Appendix 2.4: Baringa review of Evoenergy's gas demand forecast

ACT and Queanbeyan-Palerang gas network access
arrangement 2026–31

Review of Evoenergy gas demand forecasts

Final Report

Comparison of forecasts (indexed at 2024-25)

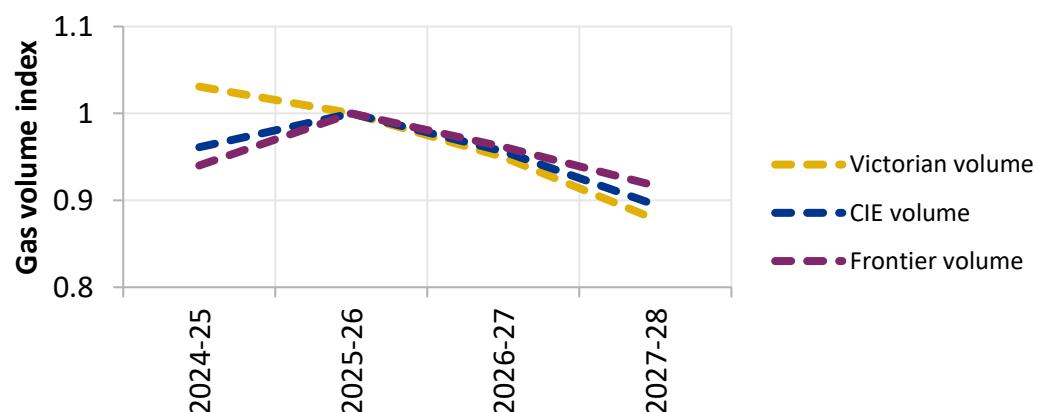
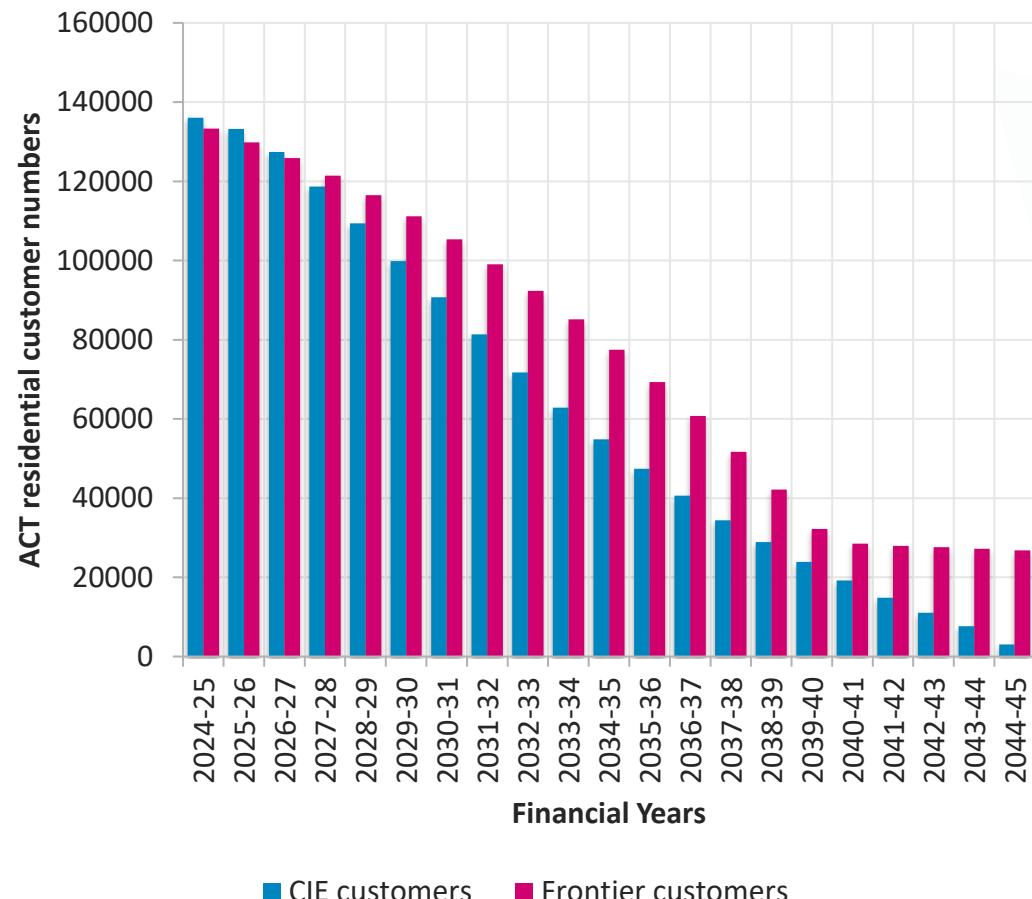
- We have compared the residential gas volume trends for the AER approved gas demand projections by the three Victorian gas distribution businesses¹ against the CIE and Frontier demand forecasts. We have provided two separate indexes starting at 1 for 2024-25 and 2025-26 for all three series due to the overlapping access arrangement periods and the order of magnitude between the gas volumes.

- The 2024-25 indexed forecast for Victoria exhibits a sharper downward trend than either the Frontier or CIE forecast, however CIE's trajectory is closer to the observed pattern in Victoria compared to Frontier, which has a slower decline. Similarly, even when indexing at 2025-26, the CIE more closely mirrors the trend in Victoria.

- ACT policy is more mature and definitive for the phase out of gas, and customer research shows that ACT customers are most motivated nationally to electrify. Overall given that we consider Victoria an informative comparator to the ACT, this suggests that the CIE's forecasts may be more accurate. Frontier's flatter trajectory implies slower behavioural change to switch, which could underestimate the pace of transition given the policy similarities in ACT and Victoria.
- We note that our top-down assessment has not investigated the Victorian forecasts in detail and there may therefore be reasons why they differ to those for the ACT.

Road to 2045 – ACT residential gas customers

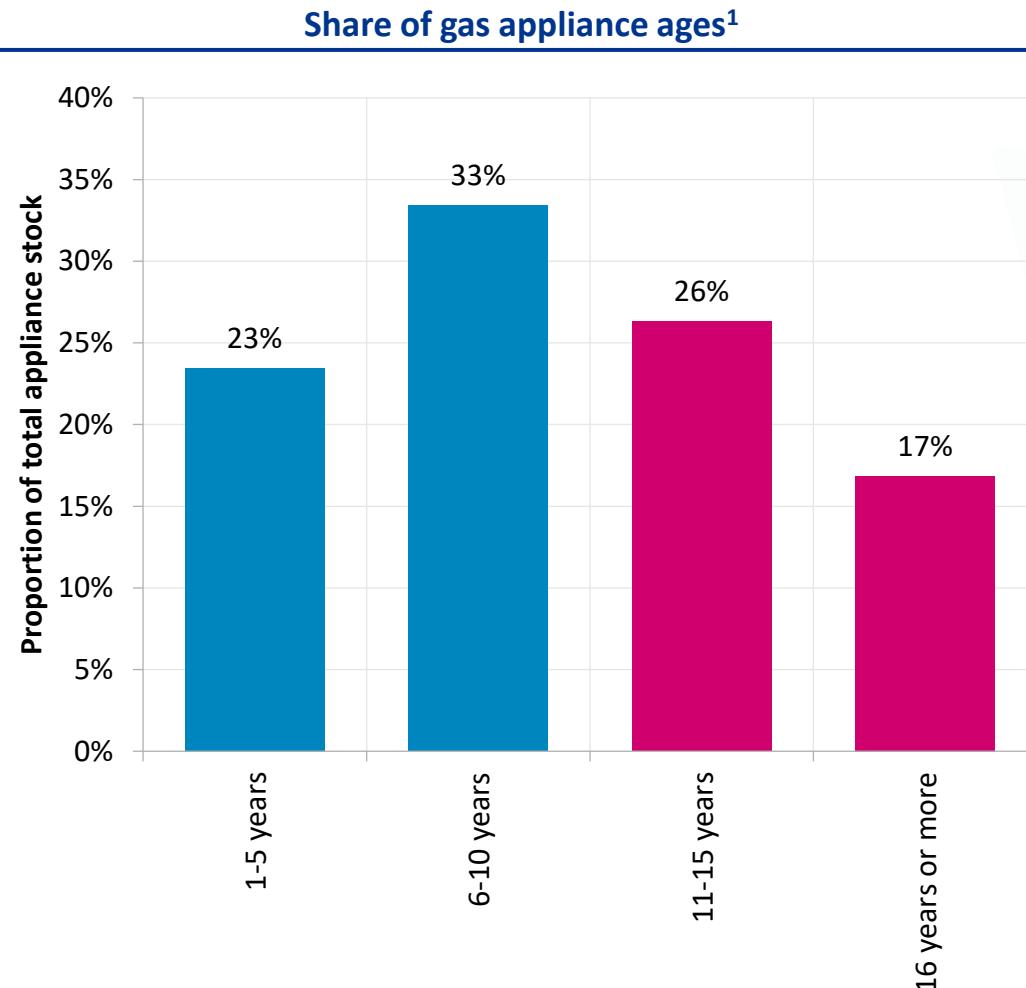
- Given the ACT Government's policy to transition away from fossil gas by 2045, we have compared the long-term projections for Evoenergy's gas connections in the ACT as produced by both CIE and Frontier.

- Both forecasts begin with similar customer numbers at around 133,000–136,000. CIE's forecast shows a steep and continuous decline, reaching 3,043 customers by June 2045 with our assumption being that by December 2045, the CIE forecasts 0 customers in line with the ACT Government targets.

- Under its switching model, CIE's forecasting approach shows a higher rate of disconnections. Conversely, under Frontier's forecast, there is still a considerable level of gas consumption with the number of customers plateauing at around 30,000 customers between 2040 and 2045. We consider that Frontier's historical trend approach understates the decline in gas disconnections.

- Overall, there is a divergence between the two forecasts starting from 2027-28, with CIE projecting an accelerated phase-out of gas customers, while Frontier assumes a slower transition.

- As Frontier retains a significant customer base beyond 2040, this implies weaker alignment with policy implementation, whereas we consider that on balance, CIE has explicitly modelled a trajectory that reaches zero gas demand and close to zero customers by 2045, demonstrating closer consistency with ACT's legislated climate and energy transition objectives.
- CIE's forecast is therefore more consistent with the stated policy goal of gas network infrastructure decommissioning and transition planning.

Disconnection forecast assessment for the ACT

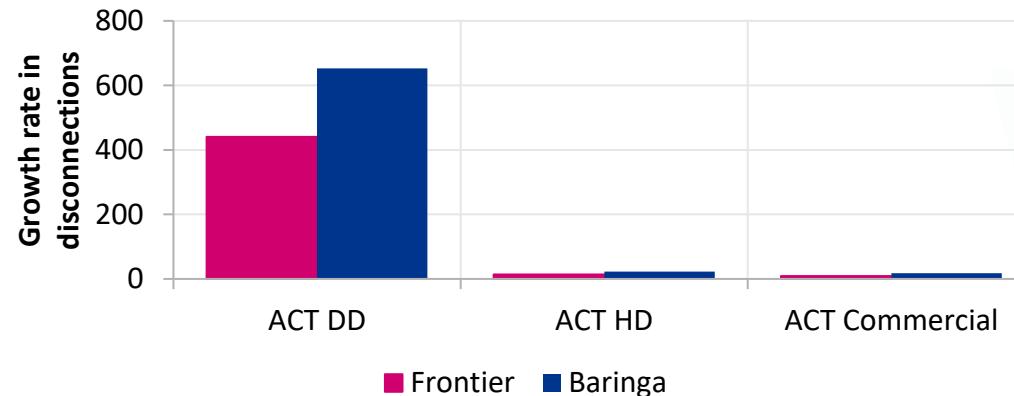
Frontier's selection of an early starting year for trending historical data has a material impact on the connections forecast in both the ACT and NSW.

- As identified in *Item #1.2* on slide 23, Frontier start their historical trend calculation from 2022/23, which is a year before the passage of the Greenhouse Gas Reduction Amendment Bill.
- We consider it is more appropriate to start the trend from the following year in 2023/24, in order to take the Bill into account. However, we recognise that this only calculates a percentage difference based on the most recent 2 years of data.
- The chart on the left shows blue (Baringa) bars that calculate disconnections based on historical trend analysis that starts in 2023/24 are higher than the pink (Frontier) bars that base the historical trend on data from 2022/23. Switching to the Baringa approach would therefore reduce gas demand from the levels estimated by Frontier.

Disconnection forecast assessment for NSW

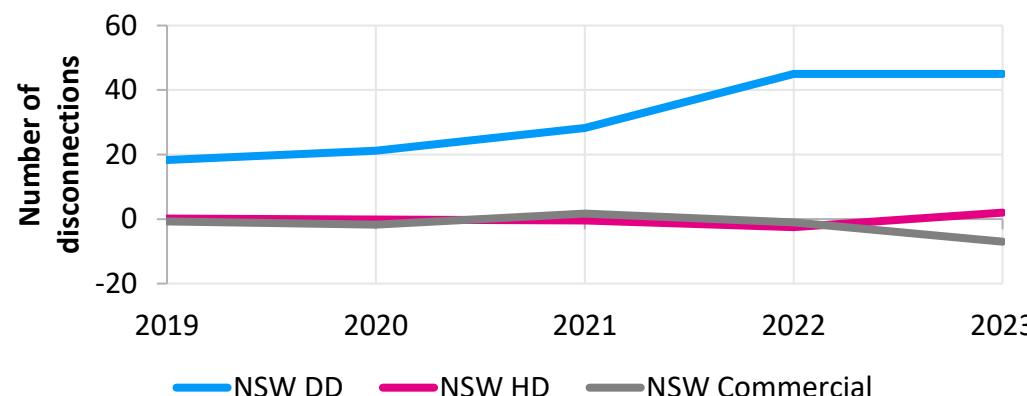
- The chart on the left calculates how the estimate of the number of NSW disconnections changes when the start financial year of the linear trend is 2019 (Frontier's selection of starting year), 2020, 2021, 2022, and 2023. These 5 linear trends are calculated separately for the 3 customer groups: detached dwellings (DD), medium density/high rise (HD) and commercial customers.

- The chart shows that the total number of disconnections is driven almost exclusively by the NSW DD customer group. It also shows that a higher disconnection forecast is calculated using any financial year after 2019 as the start year.

- Given that standing charges were removed from temporarily disconnected gas customers in October 2019, providing an incentive to temporarily disconnect, it may be more appropriate to start the trend analysis from at least 2021, as this is the first financial year where the full year of data reflects the new charging structure.

Estimated change in EDDs from regressions with different start years

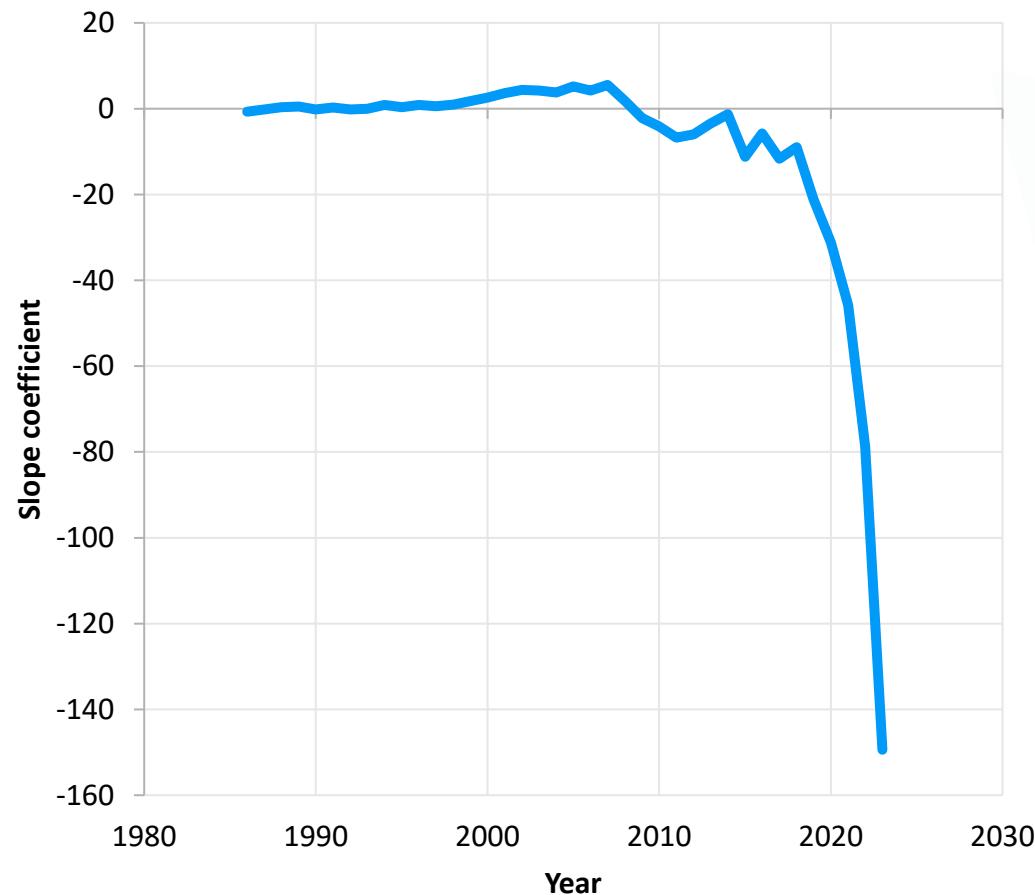
Frontier's estimated change in EDDs is likely to be too close to 0, and a more negative value could be more appropriate.

- The graph on the left shows the slope coefficient that is calculated from a regression of the number of EDDs against a time trend. The vertical axis shows how that coefficient changes when the start year of the regression moves ever closer to 2024 (the most recent year of data).

- It therefore shows that, if only more recent data is considered in the regression, any forecast based on this regression would assume that the number of EDDs falls into the future.

- Frontier estimate the change in future EDDs by performing a regression across the entirety of the available data (i.e. from 1986 to 2024). They justify this by stating it captures long-term climate trends and to avoid the effects of year-to-year weather.

- Our view is that Frontier's aim here is correct, but it ignores the fact that accelerating climate change may mean that historic trends from 1986 are not reflective of future environmental conditions.
